UNITED STATES PATENT AND TRADEMARK OFFICE

09/766,749

Non-Final Rejection (RCE)

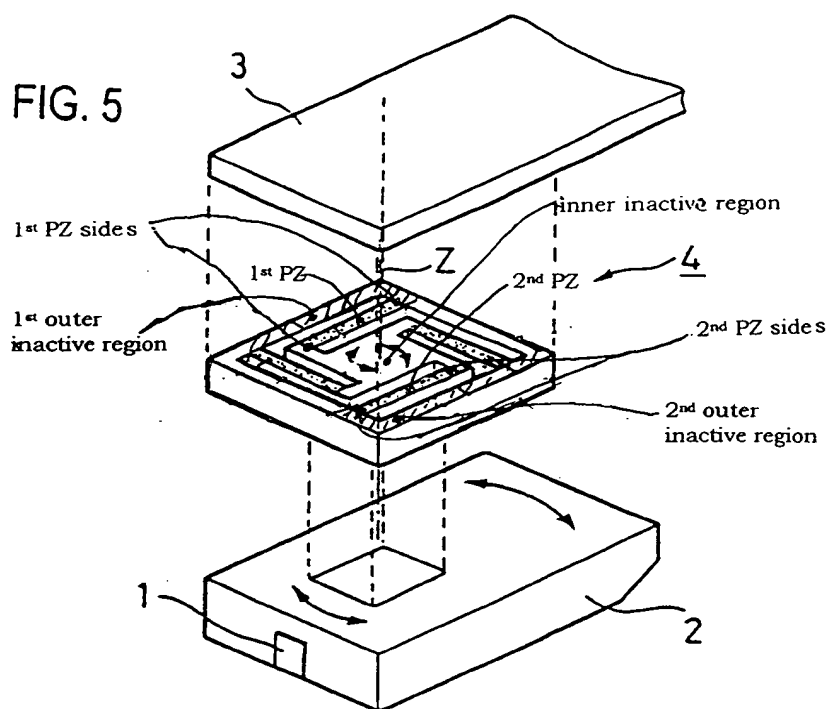
With regard to claims 1-3 and 8-10, Soeno et al shows a disc drive actuation system for precisely positioning a read/write head over a selected track of a rotatable disc (Figs. 5 18-19), the system including: A) a flexure (means) 31 (Fig. 18B; column 27, line 41), B) a slider (means) 2 (Column 13, line 44), C) a read/write head 1 firmly

attached to the slider, D) a first drive unit (means) 5 (Fig. 32, column 1, line 55) for pivoting the flexure to position the read/write head (means) approximately over the selected track, which is a voice coil motor, E) a microactuator 4 (Figs. 5 and 18) including: 1) an inner inactive region 44, 2) a first outer inactive region (See attached Fig. 5 with added numerals in next page) a second outer inactive region (See attached Fig. 5), 4) a first piezoelectric section sandwiched between the first outer inactive region and the inner inactive region, 5) a second piezoelectric section sandwiched

between the second outer inactive region and the inner inactive region, wherein the inner inactive region is sandwiched between the first piezoelectric section and second piezoelectric section and firmly attached to the slider (means) and both of the outer

inactive regions being firmly attached to the flexure (means) (Column 6, lines 35-37), 6) an inherent electrical circuit for energizing the first and the second piezoelectric sections to cause them to expand and contract in order to precisely position the read/write head (means) over the selected track (Column 34,, lines 44-57), the circuit and the piezoelectric sections being configured such that the first piezoelectric section expands when the second piezoelectric section contracts and the first piezoelectric section contracts when the second piezoelectric section expands, which is shown in Fig. 5, wherein the above mentioned action causes the slider on 44 to rotate as shown in Fig. 5.

With regard to claim 15, Soeno et al further shows the slide is independently supported by the microactuator (Fig. 5).

With regard to claims 23, 24, and 25; Soeno et al further shows the first piezoelectric section includes two first piezoelectric sides, wherein both of the first piezoelectric sides are opposite to each other (See attached Fig. 5), and wherein the second piezoelectric section includes two second piezoelectric sides (See attached Fig.

5), wherein both of the second piezoelectric sides are opposite to each other, wherein one of the two first piezoelectric sides is rigidly attached to the first outer inactive region and wherein the other of the two first piezoelectric sides is rigidly attached to the inner inactive region, and wherein one of the two second piezoelectric sides is rigidly attached to the second outer inactive region and wherein the other of the two second piezoelectric sides is rigidly attached to the inner inactive region.
